This document is created in order to clarify some grey areas of FS Rules 2026 v1.1 and to specify the policies Formula IHU is going to follow about them.
Wherever applicable, this document supersedes FS Rules 2026 v1.1.

T 10.2.2 Correctly Installed Safety Wiring

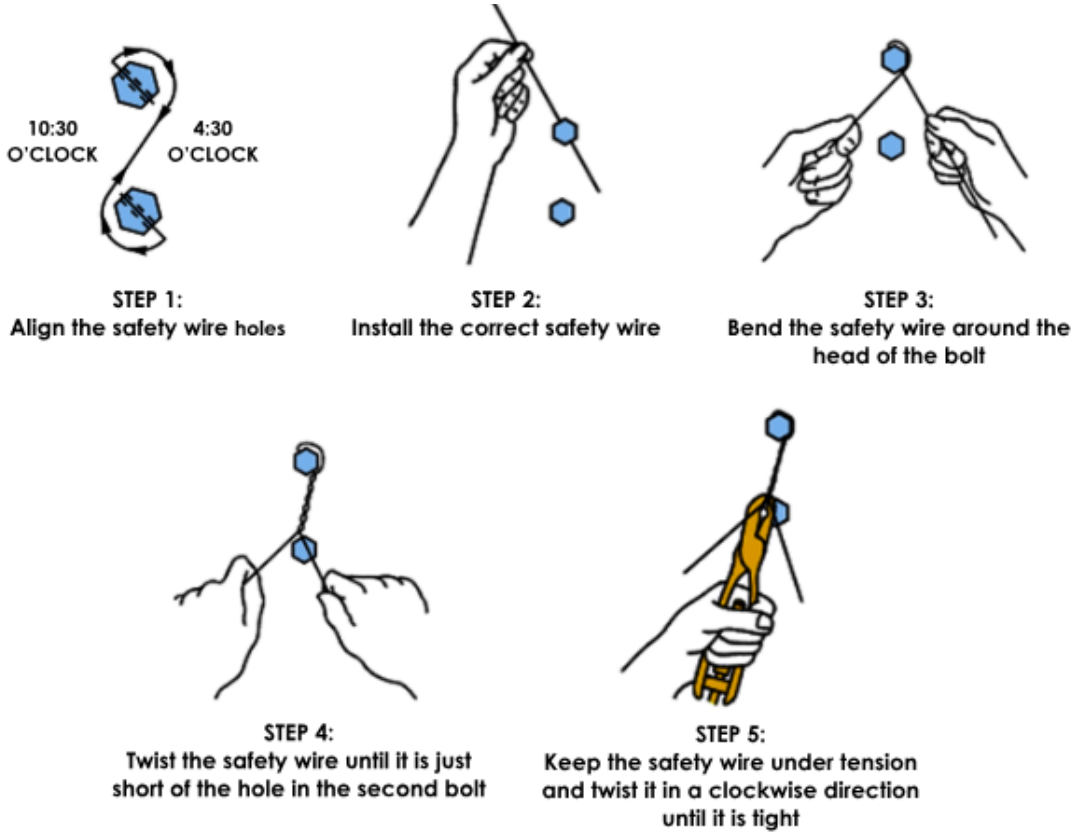
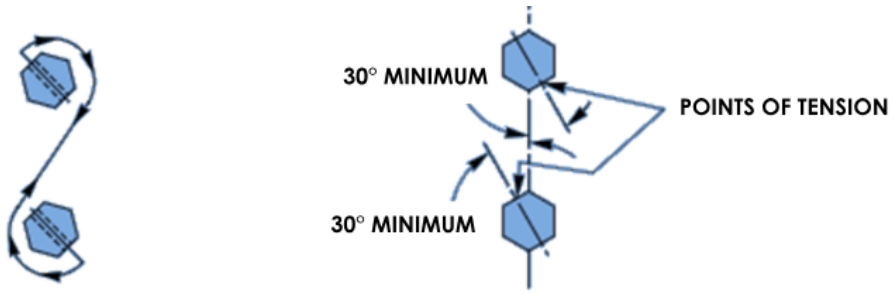
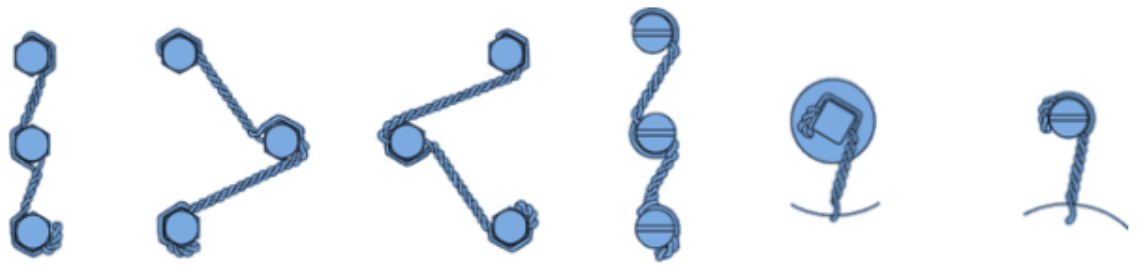
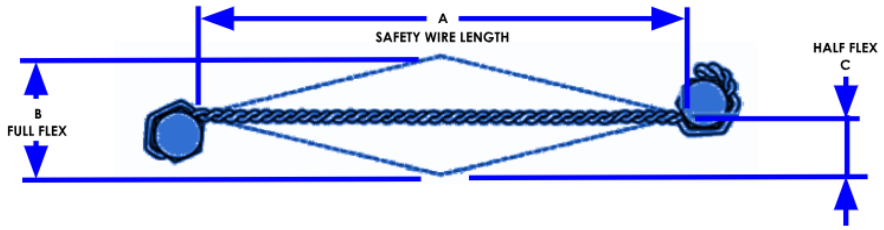
To determine a safety wiring as correctly installed, the process and the result must comply with the following:

Be mindful of the direction of the holes as well as the points of tension of the safety wire, as shown below:

Acceptable examples of safety wiring:

To declare a safety wiring as sufficient, regarding its flexibility, it must pass the following test:

- Push the safety wire at mid-span with light finger pressure
- The total flex must not be more than the limits shown in the following table:

T 4.8 Firewall

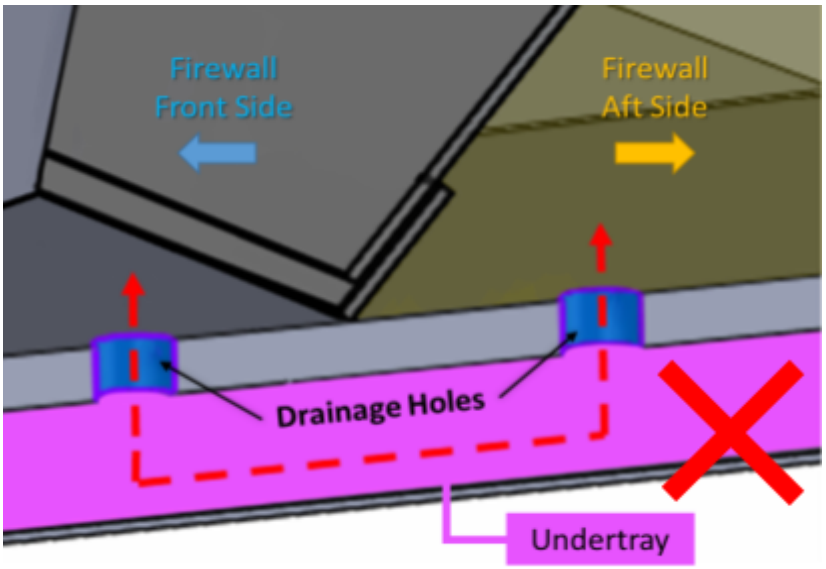
- During mechanical inspection your firewall is going to be inspected for possible openings with a flashlight. In addition to T4.8, for a firewall to be accepted, no light must be visible in the cockpit area when illuminated from the rear.
- An undertray assembly must <u>not</u> be able to connect the drainage holes in the adjacent sides of a firewall as shown in the example of the figure below.
- **CV ONLY**: Regarding T4.8.4, all materials employed to prevent the passage of fluids shall be resistant to fuel-induced corrosion and also be fire retardant as defined in T1.2.1.

T 3.14 Front Bulkhead Support Structure for Tubular Chassis

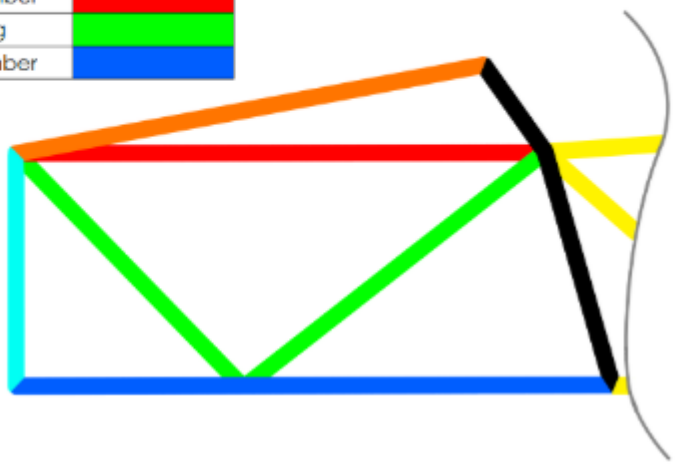
Specification for the front bulkhead support structure of a tubular chassis.
